SERVICE BULLETIN 43

SUBJECT: POSSIBLE INCORRECT CABLE THIMBLE INSTALLATION

APPLICATION: All Glasair I, Glasair II, and Glasair III aircraft shipped prior to 10/08/87.

FIGURE (1)

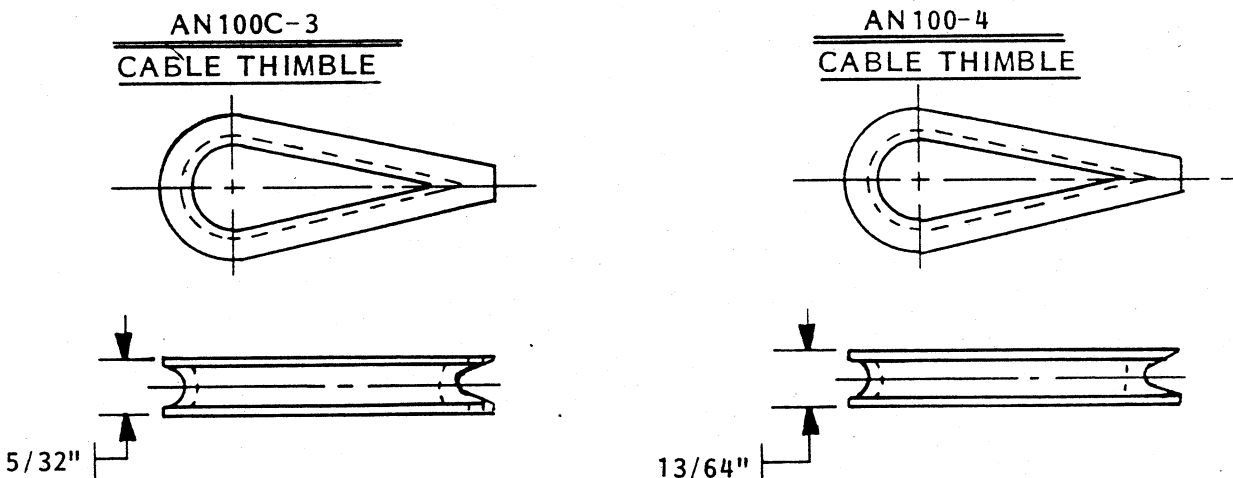
We have discovered that, in recent Glasair kits, we have inadvertently been supplying AN100C-3 cable thimbles in place of AN100-4 cable thimbles. The AN100C-3 is intended to be used only with 3/32" diameter cable. If an AN100C-3 thimble is used in place of an AN100-4 thimble on the larger 1/8" diameter cable, the cable would not rest uniformly in the thimble groove and could be weakened by bearing against the sharp edges of the groove.

There is very little external difference between the AN100C-3 cable thimble and the AN100-4 cable thimble. The significant difference is the width of the cable opening of the thimble, as shown in FIGURE (1).

NOTE: The outside dimensions of the cable thimbles are shown in FIGURE (1) because it would be difficult to measure the inside dimensions if the thimble has already been installed in a cable assembly.

SOLUTION: We have no way of determining who may have received the incorrectly labeled cable thimbles and are therefore asking all Glasair builders to inspect all cables thimbles in their kit or on their aircraft to verify that the correct thimbles have been supplied and installed.

Inspect the cable thimbles supplied with your kit, referring to FIGURE (1) to determine their sizes.
